**Proposal for draft amendments to Regulation No 107**  
(M<sub>2</sub> and M<sub>3</sub> vehicles)

B. PROPOSAL

Annex 3, insert a new paragraph 7.7.15., to read:

Figure 1

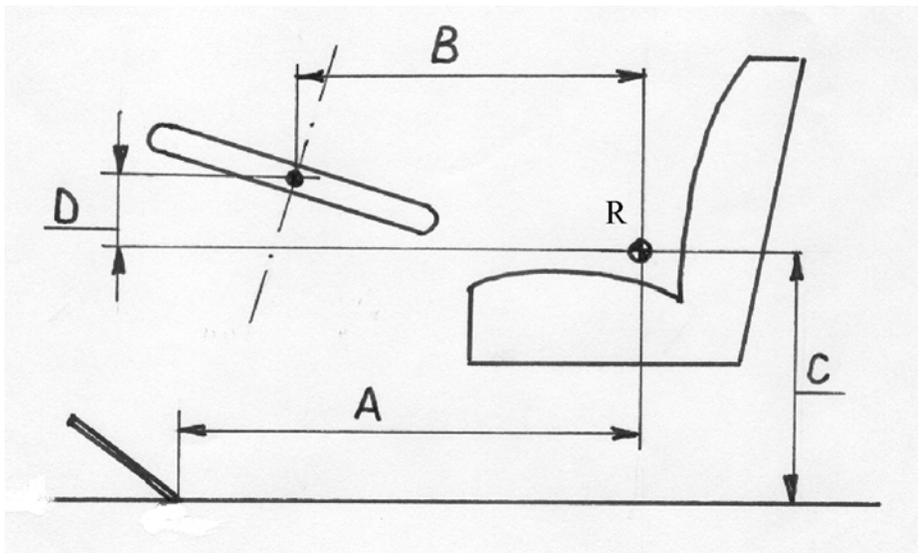
**7.7.15.1. The driver's seat, the steering wheel and the gas pedal shall have their basic common position as it is shown on figure 1:**

**7.7.15.1.1. the vertical position of the driver seat's R point above the floor level of the driver compartment (C=420 mm);**

**7.7.15.1.2. the vertical position of the centre of the steering wheel related to the driver seat's R point (D=250 mm);**

**7.7.15.1.3. the horizontal position of the driver seat's R point to the heel point of the gas pedal (A=730 mm);**

**7.7.15.1.4. the horizontal distance between the driver seat's R point and the centre of the steering wheel (B= 500 mm).**
